EXHIBIT A

PERMIT NO.: B2308873

Address of Project: 638 1 ST NE		Zone: RF-1	Ward: 6	Square: 0857	Suffix: 0819	Lot:
Permit Restrictions: HERITAGE/SPECIAL TREES, YEARBUILTPRIOR1978						
Permission Is Hereby Granted To: Chen, Kevin R		Owner Address: 638 1 ST NE WASHINGTON, DC 20002			PERMIT FEE: \$6,802.27	
Permit Type: Addition Alteration Repair	Existing Use: One Family	Proposed Use: One Family	Building Construction Type: TYPE V - Any Materials Permitted			Floor(s): 0
Agent Name / Address: Andrew Murray 443 2nd Street Se	Contractor Name / Address : Chen, Kevin R 638 1 ST NE WASHINGTON, DC 20002			Existing Dwell Units: 1	Proposed Dwell Units: 1	No. of Stories: 2

Fw: Challenge to permit for 638 1 ST NE - B2308873 Open2/7/2024 •  Satisfied

DOB Ex. B- BZA Case 21142

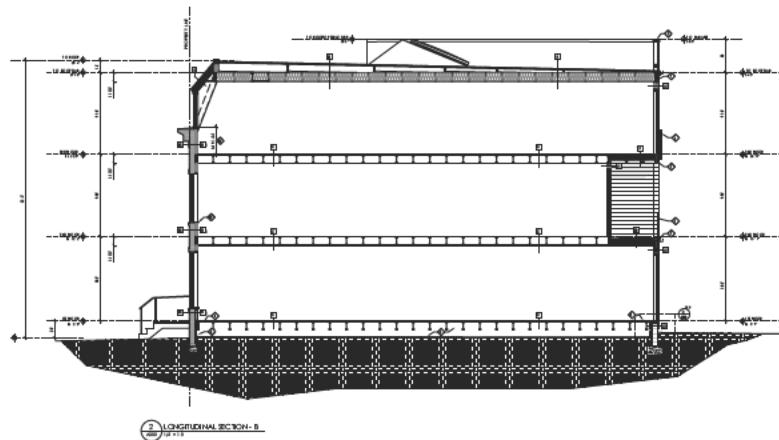
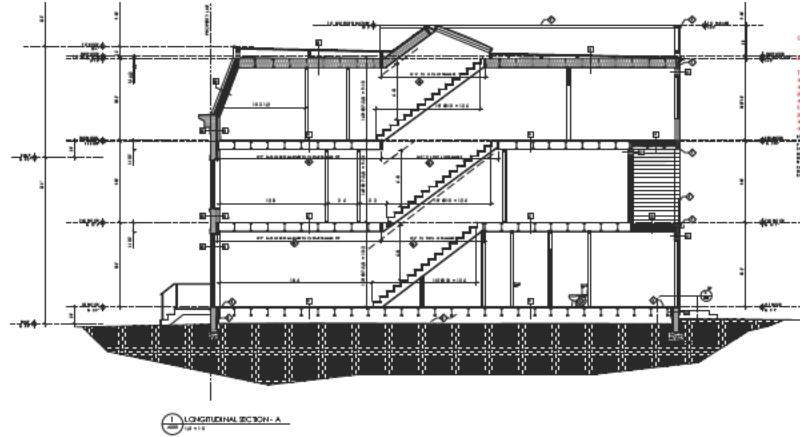
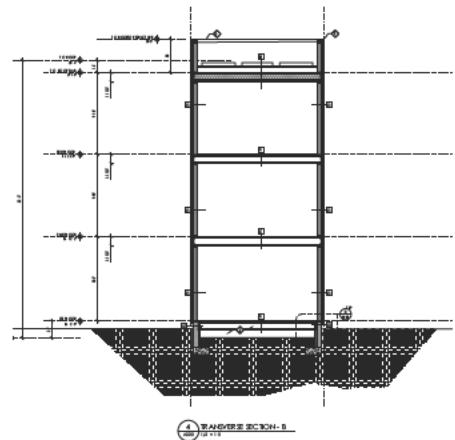
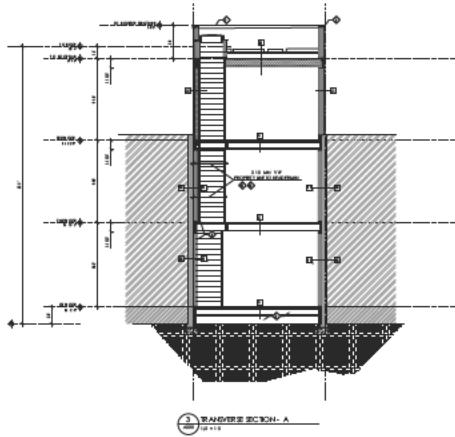
Please accept this email as a challenge to the issuance of the above referenced building permit. The approved permit drawings are not consistent with the Zoning Administrator's Interpretation 7 regarding required setbacks from protected architecture rooftop elements.

The attached excerpt from the permit drawings depicts a rooftop addition that is coincident with the front facade and cornice, not set back 3 feet. A copy of interpretation 7 downloaded from the DOB website this morning is also attached for reference. Please review and, if you are in agreement, revoke the permit.

That's a rather odd position to take, given that section 206.1 expressly includes cornices: "a roof top architectural element original to a principal building such as cornices, porch roofs, a turret, tower, or dormers"

Thank you for your email regarding B2308873. You inquired about whether B2308873 should be revoked because the proposed addition is not set back a minimum of three feet from the existing cornice and you referenced ZA Interpretation #7 which is as follows:

The ZA interpretation applies in cases a new addition is proposed and states that the addition has to be set back a minimum of 3 feet from the roof-top architectural embellishment, like a turret. The rationale behind the interpretation is to protect the architectural integrity of the existing roof-top architectural embellishment, so that it does not lose its defining features by being incorporated into the new addition.

Consistent with the past practice under the former Zoning Administrator, a cornice is not a roof-top architectural embellishment and therefore a new addition may be constructed flush with an existing cornice.
